Access Compliance Report

Public Rights-of-Way

Intersection ID: 3441	Main Street: KATELYN_DR	Cross Street: SILVERMERE_WY	Location: NW
ADA ID: F106514A8A49	Ramp Type: BlendTrans1	Initial Pass/Fail: Pass	Overall Compliance: No
		Severity Score: 7.5

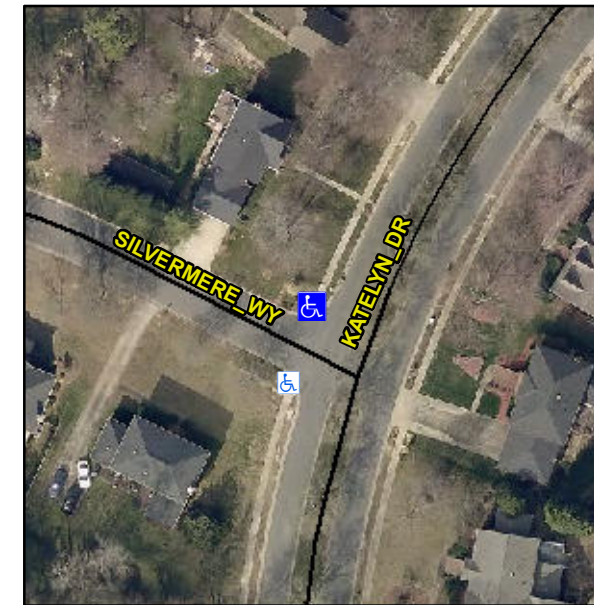
Not Found, R305.2, R302.7.2

Compliance	Description	Data	Compliance	Description	Data
N/A	Ramp Length (in)	38.0	Yes	BlendTrans Slope (%)	3.8
Yes	Ramp Width (in)	48.0	Yes	BlendTrans XSlope (%)	0.6
N/A	Flare Type LT	Sloped	N/A	Flare Type RT	Sloped
N/A	Flare Slope LT (%)	8.1	N/A	Flare Slope RT (%)	11.8
N/A	Flare Traversable LT?	No	N/A	Flare Traversable RT?	No
Yes	Landing Length (in)	48.5	Yes	DWS Provided?	Yes
Yes	Landing Width (in)	49.0	Yes	DWS Contrast?	Yes
Yes	Landing Slope (%)	1.8	Yes	DWS Length (in)	24.0
Yes	Landing X Slope (%)	0.3	Yes	DWS Full Width?	Yes
N/A	Landing Curb? (Y/N)	No	No	DWS Offset (in)	3.4
N/A	Shared Landing?	No			
Yes	Gutter Ponding?	No	Yes	Gutter Slope (%)	0.9
No	Gutter Lip Ht (in)	0.5	Yes	Gutter X Slope (%)	1.9
N/A	Painted X Walk1?	No	N/A	Painted X Walk2?	N/A
	X Walk 1 Direction	To S		X Walk 2 Direction	N/A
	X Walk 1 Width (in)	N/A		X Walk 2 Width (in)	N/A
	X Walk 1 Slope (%)	3.2		X Walk 2 Slope (%)	N/A
	X Walk 1 X Slope (%)	0.3		X Walk 2 X Slope (%)	N/A

N/A	Ramp inside XWalk1?	N/A	N/A	Ramp inside XWalk2?	N/A
	Road Slope (%)	0.3		Clear Space?	Yes
	Road X Slope (%)	3.2	N/A	Clear Space to XWalk (in)	N/A
Yes	Any Obstructions?	No	Yes	Storm Grate/Utility Hazard?	No
	Obstruction Type			Storm Grate/Utility Type	
		N/A			N/A
			Yes	Surface Condition? (G/P)	Good
			No	Curb Slope (%)	24.7

Remove & Replace Curb Ramp With Two New Directional Ramps or Equivalent.
